PROPOSED BUILDING AMENDMENTS

Gorton Centrepoint

Proposed Roof Plan (Comparative Overlay)

GCP-KMA-XX-XX-DR-A-7010

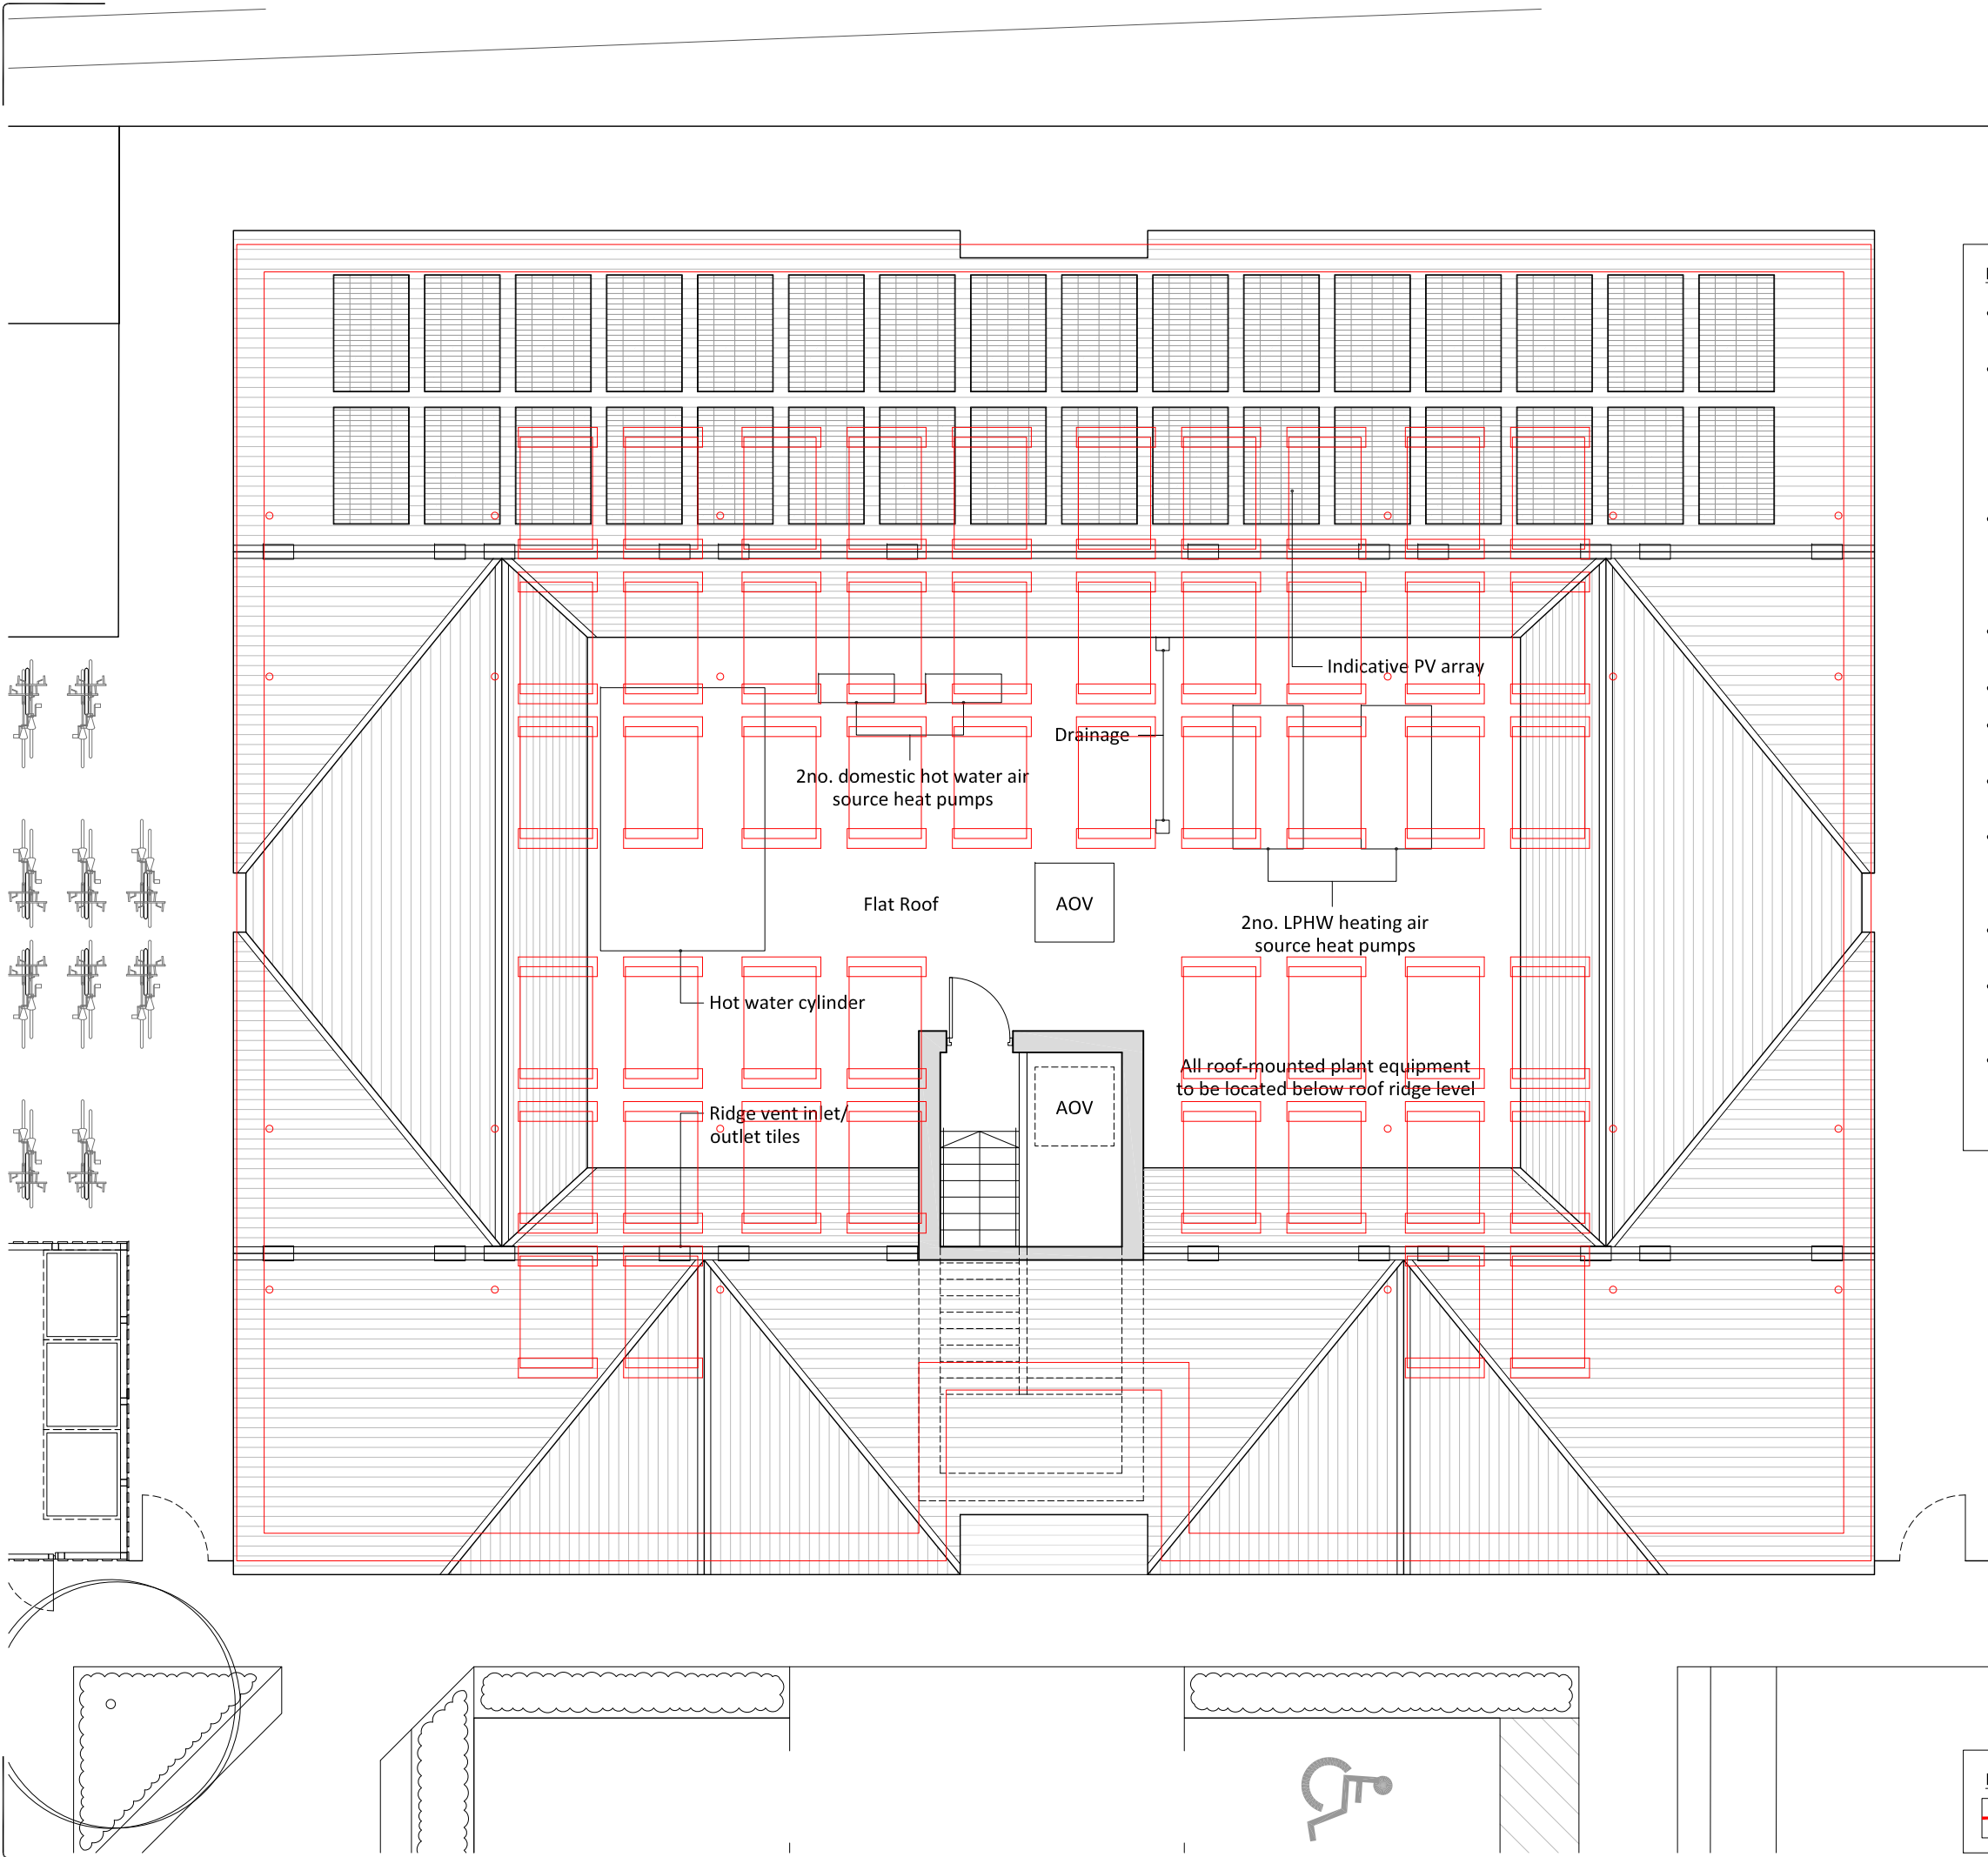
- 2no. (minimal) feature gable projections to be added to the principal elevation.
- The approved flat roof and parapet detail have been replaced with a traditional pitched roof. The proposed ridge height is to remain the same as the approved parapet, but the proposed (lower) eaves height shall reduce the overall visual mass of the building.

- A concealed plant area (securely accessed via the main stair) is located upon the proposed central flat roof section, to be hidden from view by the pitched roof returning front-to-back to form a visual barrier.

- The main entrance is to be pulled forward, but not beyond the approved building line/principal elevation.
- The main entrance is to include for a proposed canopy.

- All solar assisted heating panels are to be removed from the front and rear elevations.
- A PV array is now proposed to the south-facing roof to assist with energy generation.

- All juliet balconies and associated doors to each apartment are to be replaced with larger openable windows on the front and rear elevations.
- Wall recesses and full-height glazing are to be added to the corridors within each gable end.

- Additional small windows are proposed within each gable end, with no overlooking issues to either the west or east.
- The proposed material palette is to match the adjacent GMYF building in terms of the proposed red facing bricks, artificial slate roof and glazing.
